The District of North Vancouver REPORT TO COUNCIL

May 12, 2026
File: 08.3060.20/039.25
Case: PLN2025-00039

SUBJECT: OCP Amendment & Rezoning Application – 328 - 332 Seymour River Place

Figure 3 – At Grade Parking

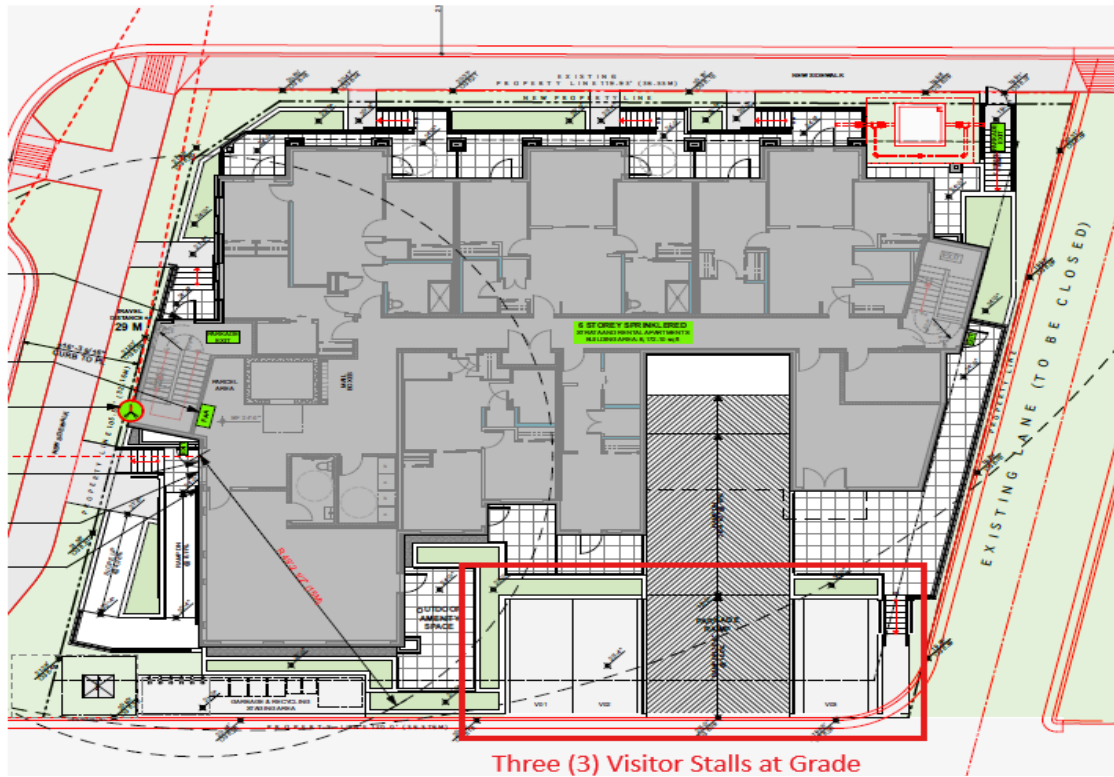
For information, the tables below show the proposed parking of 26 stalls in comparison with the base parking requirement under zoning, and with the AVPR policy (see also Figure 3 – At Grade Parking and Figure 4 - P1 Parkade, for parking configuration). They indicate a significant deficiency with the proposed parking.

Base Parking Requirement	Proposed	Difference
Total Required	74	26	-48
Visitor	10	4	-6
Universal	6	2	-4
Effective Rate	1.85 / unit	0.65 / unit	-1.20 / unit

Min. AVPR Parking Requirement*	Proposed	Difference
Total Required	36	26	-10
Visitor	2	4	+2
Universal	4	2	-2
Effective Rate	0.9/unit	0.65 / unit	-0.25 / unit

One, staff recommend that the application be revised to be consistent with the minimum parking requirements found in the Districts' AVPR policy, predicated on a TIA and TDM plan that shows specific, significant, and achievable actions to mitigate impacts that the limited parking may have in the area. *This will likely require a commensurate reduction in density.*
